APPENDIX A
RECLAMATION PLAN TABLES AND FIGURES

FIELD DESIGN MODIFICATIONS CENTRAL AND SOUTH CELL RECLAMATION

Transmittal
Field Design Modifications
Central and South Cell Reclamation

CHURCH ROCK SITE
CENTRAL CELL RECLAMATION

MODIFIED DESIGN OF SWALES B & C
Scale : 1" = 100'

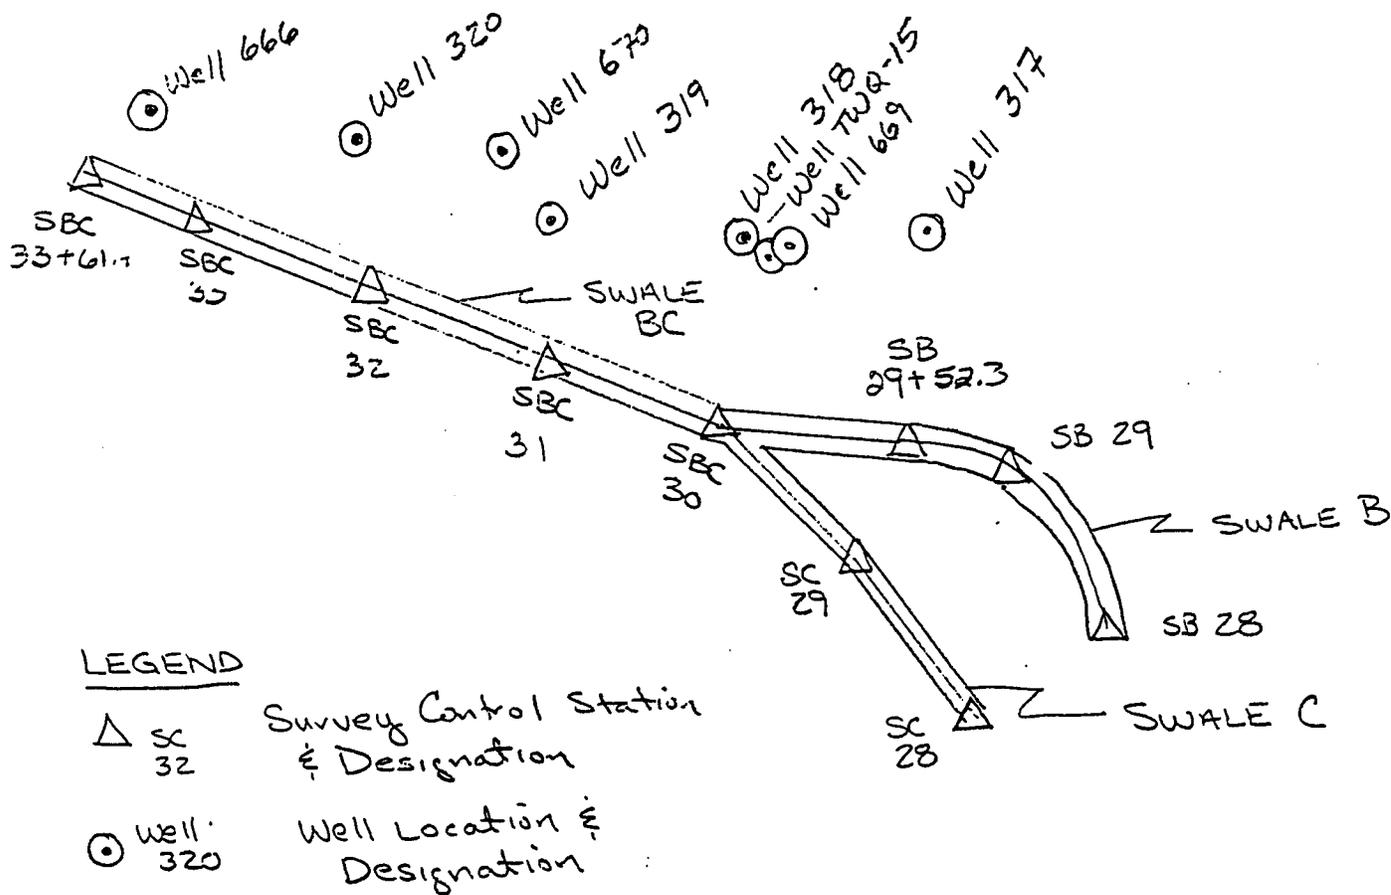
Branch Swale B of the Central Cell was originally designed to pass through the area where the North Cross-Dike Pump-Back Wells are located prior to discharging into the North Cell Drainage Channel. This design was based on the assumption that ground water remediation in Zone 1 would be completed by this time and that the North Cross-Dike Pump-Back Wells would be decommissioned. This was a reasonable design assumption given the limited ground water impacts in Zone 1 and concurrence by the regulatory agencies that extensive remediation in this formation was infeasible. Unfortunately, regulatory delays have caused the remediation of Zone 1 to be extended, and the wells, although currently inactive, have not been approved for decommissioning.

To avoid unnecessary delays in the reclamation of the tailings disposal area, United Nuclear has proposed rerouting the final 367 feet of Swale B around the North Cross-Dike Pump-Back Wells by combining Swale B with Swale C at Survey Station 30+00, as

shown on the enclosed sketch. The grade of Swales B and BC are to be 0.0102 from Stations SB 27 to SBC 31 and 0.083 from Stations SB 31 to SB 33+61.7. Canonie/Smith Environmental Technologies Corporation has reviewed this field modification to the reclamation design and has determined that it is consistent with the NRC's reclamation guidelines and the approved reclamation plan, provided that the modified design incorporates the following:

1. The combined swale is to be 20 feet wide at its base and armored with riprap having a D_{50} of 3.0 inches.
2. The combined swale is to be 2.1 feet deep or deeper to allow for adequate freeboard during the design event.

Specific Gravity increased from 2.5 to 2.72 to match as-built conditions
 Rip rap D50 increased from 0.125 FT to 0.25 FT
 Swale A discharge of 40 cfs added to original 97 cfs

FIELD DESIGN MODIFICATION SWALES H, I & J

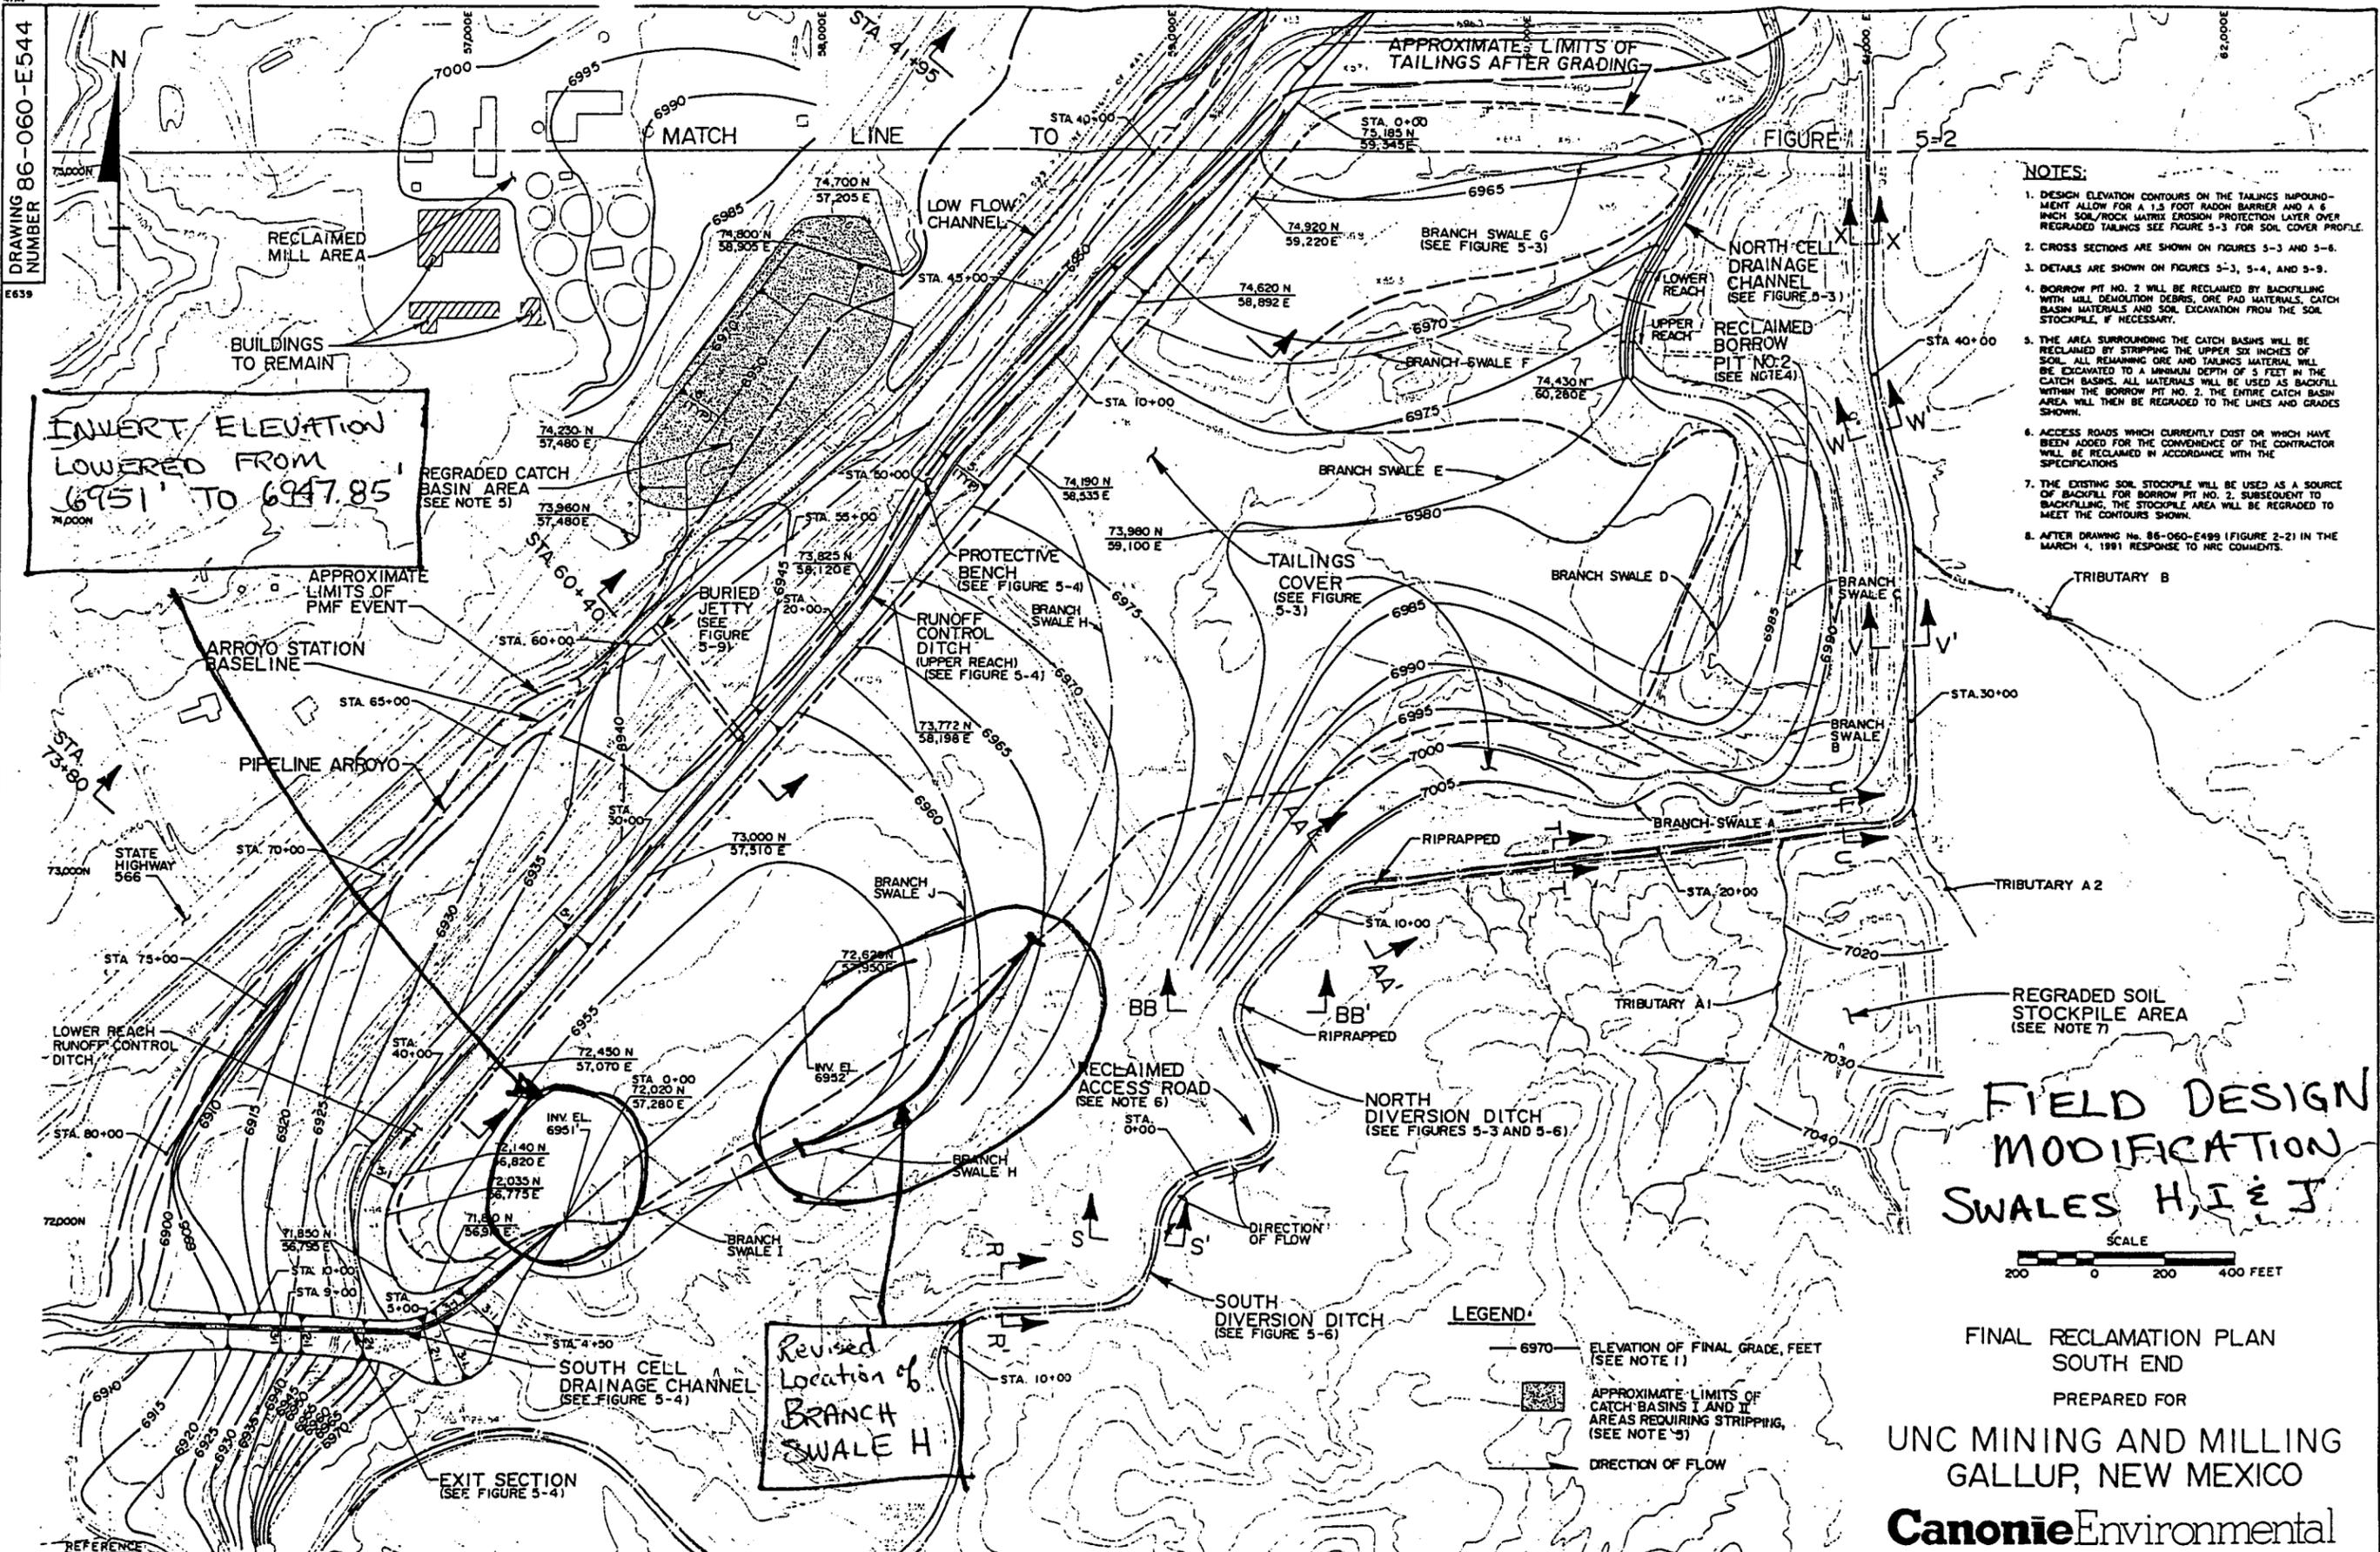
The lower portion of Branch Swale H was originally designed to pass through the bedrock outcrop area southeast of the South Cell of the tailings area. However, this design requires substantial excavation in the bedrock to construct the swale to the design grade. United Nuclear has proposed moving Swale H closer to the tailings areas as shown on the enclosed modified Figure 5-1. The invert elevation where Swale I flows into the South Cell Drainage Channel will also require modification from an elevation of 6951 feet to approximately 6947.85 feet (assuming a 3.5-foot deep swale) to match Swale I to the South Cell as-built contours.

These two field modifications result in moving the juncture between Swales J and H approximately 200 feet further to the northeast and increasing the grades of Swale I from 0.0040 to 0.0067 and Swale H from 0.0085 to 0.010. The grade of Swale J will remain the same at 0.0047. These modifications will not require any change in specified swale depths, bedding material or riprap because the calculated safety factors remain above 1.0. A copy of the supporting calculations for the changes in configuration of Swales H, I and J is enclosed.

INVERT ELEVATION LOWERED FROM 6951' TO 6947.85'

Revised Location of BRANCH SWALE H

SPECIFIC GRAVITY INCREASED FROM 2.5 TO 2.72 TO MATCH AS-BUILT CONDITIONS
CHANNEL SLOPE INCREASED TO 0.067 (ASSUMES 3.5 FT DEPTH AT END OF SWALE I)

SPECIFIC GRAVITY INCREASED FROM 2.5 TO 2.72 TO MATCH AS-BUILT CONDITIONS
SLOPE INCREASED FROM 0.0085 TO 0.010

FIGURE 1
BEDDING LAYER GRADATIONS

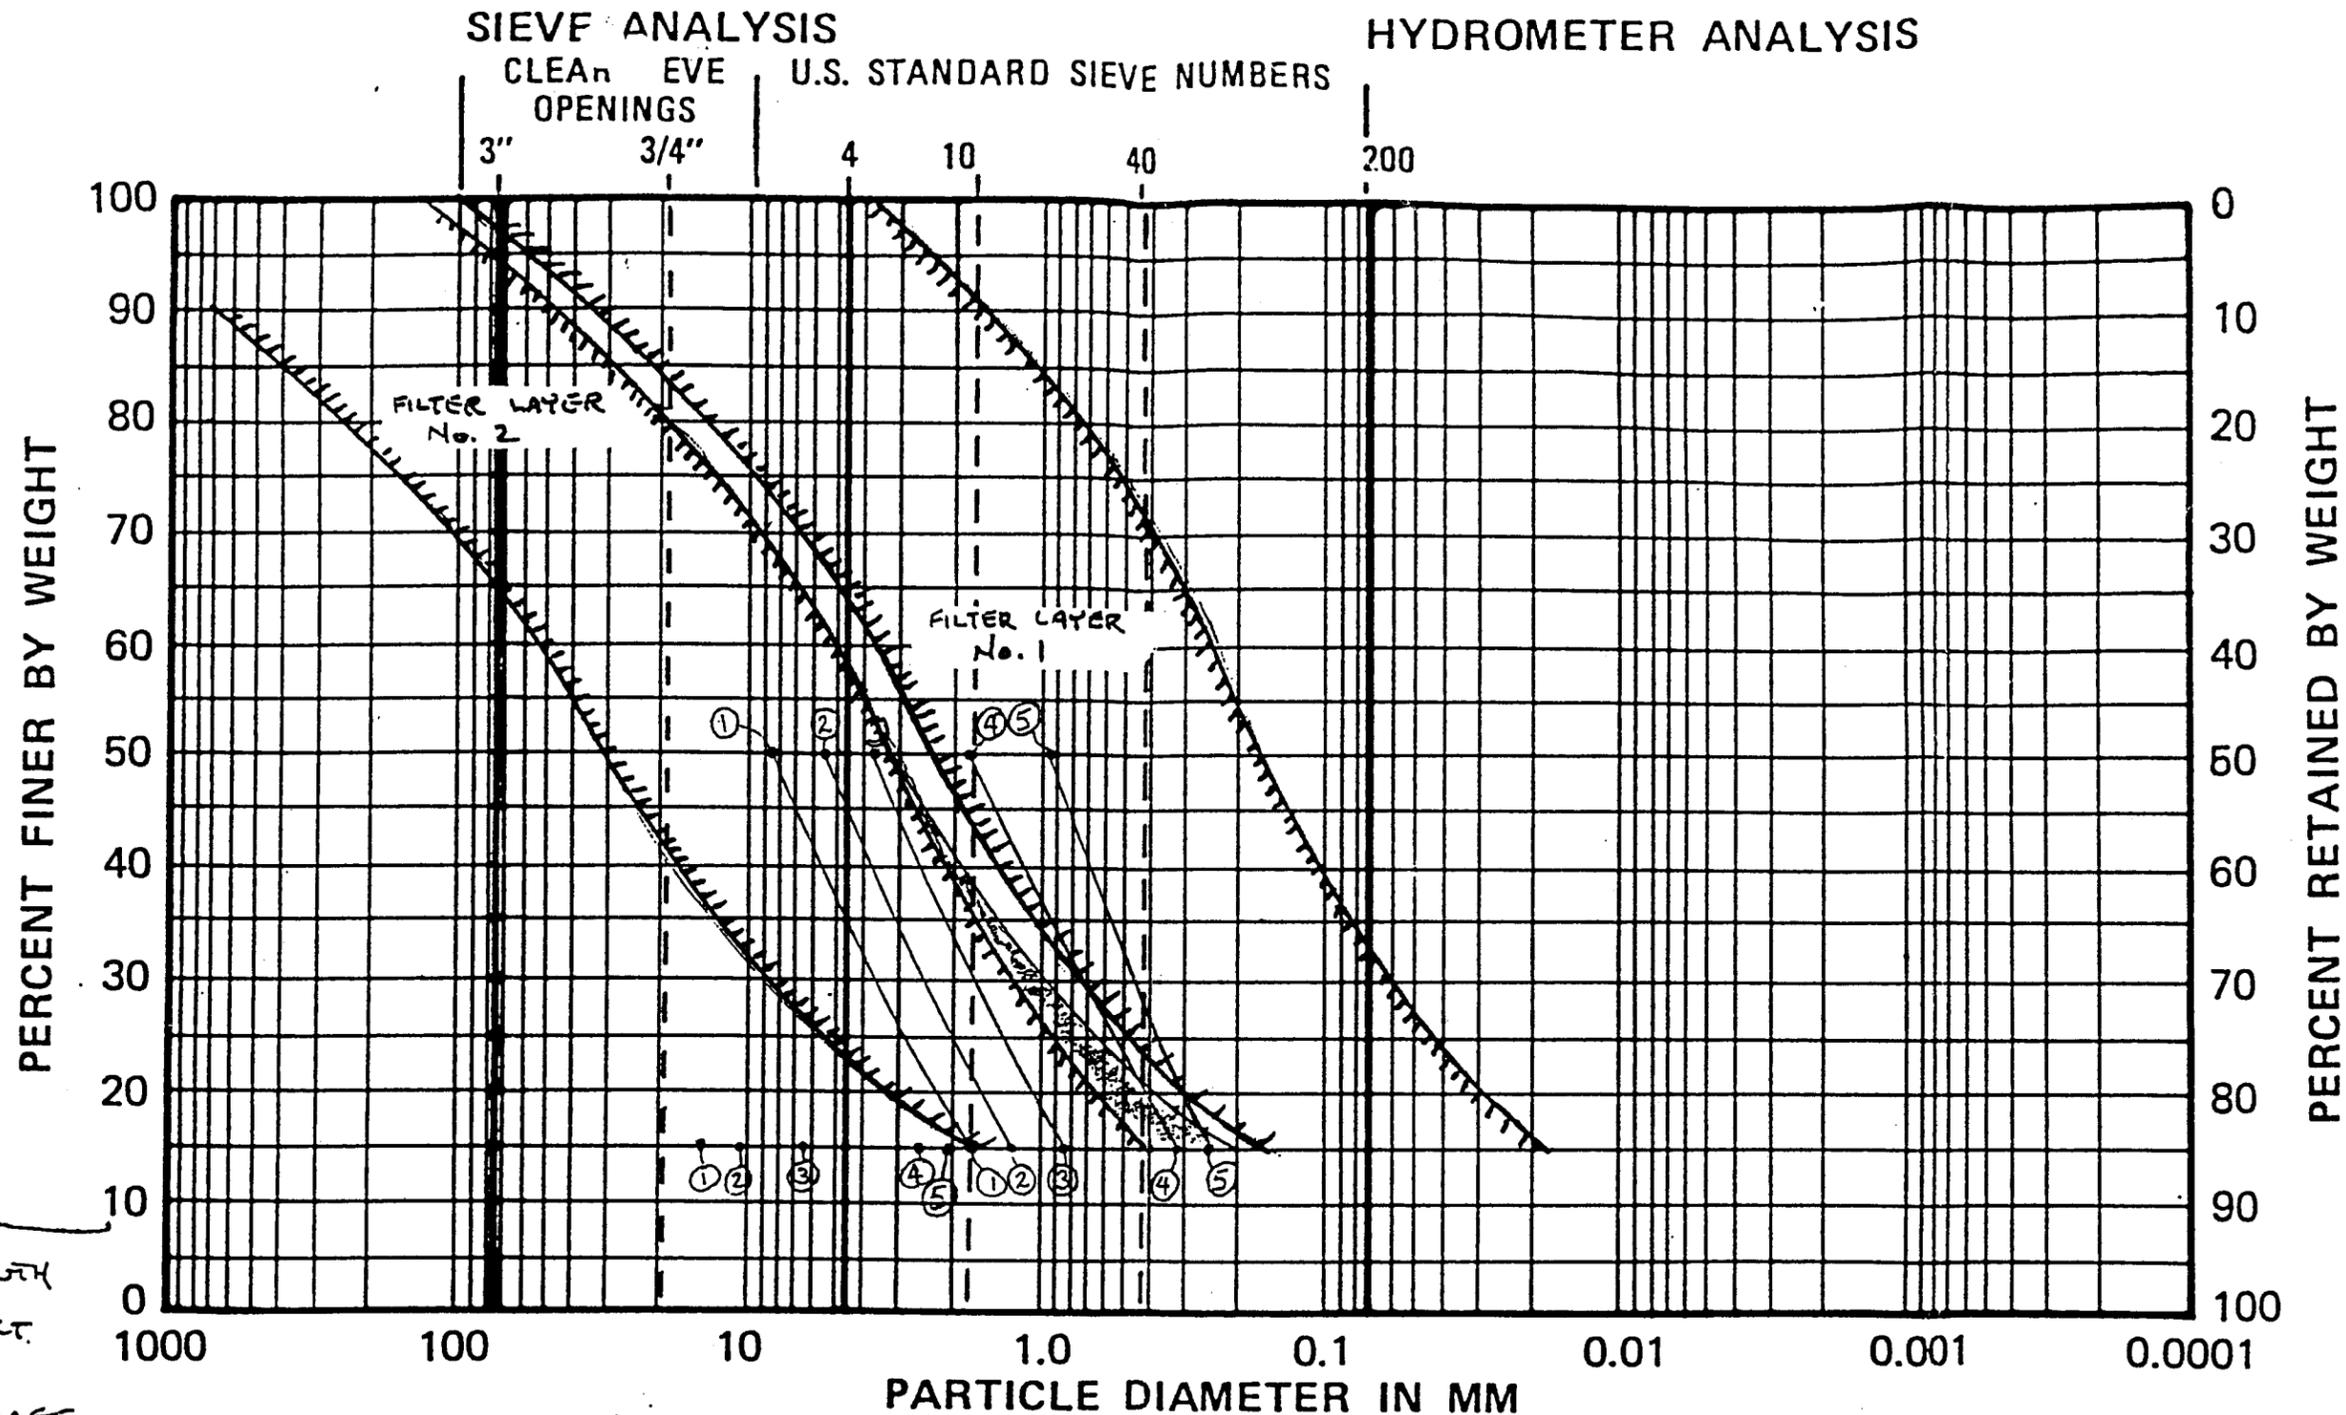
The reclamation plan calls for the placement of Bedding Layer 2 in a number of channels and swales, including Branch Swales H and I, which are to be completed this year. The bedding gradation specification listed in Table 5.7 of the reclamation plan calls for 5 to 12 percent passing the No. 40 screen size. However, the bedding material produced by the quarry is typically running about 14 percent passing the No. 40 screen.

Review of the original gradation calculations presented in United Nuclear's March 1991 response to NRC comments shows that Bedding Layer 2 (also called Filter Layer No. 2) can have up to 20 percent passing the No. 40 screen size in Swales H and I and the Lower Reach of the Runoff Control Ditch. Therefore, use of the finer gradation is acceptable for these areas, but would be unacceptable for the South and North Cell Drainage Channels and the North Diversion Ditch. Figure 1 of the original gradation calculations is enclosed for reference purposes.
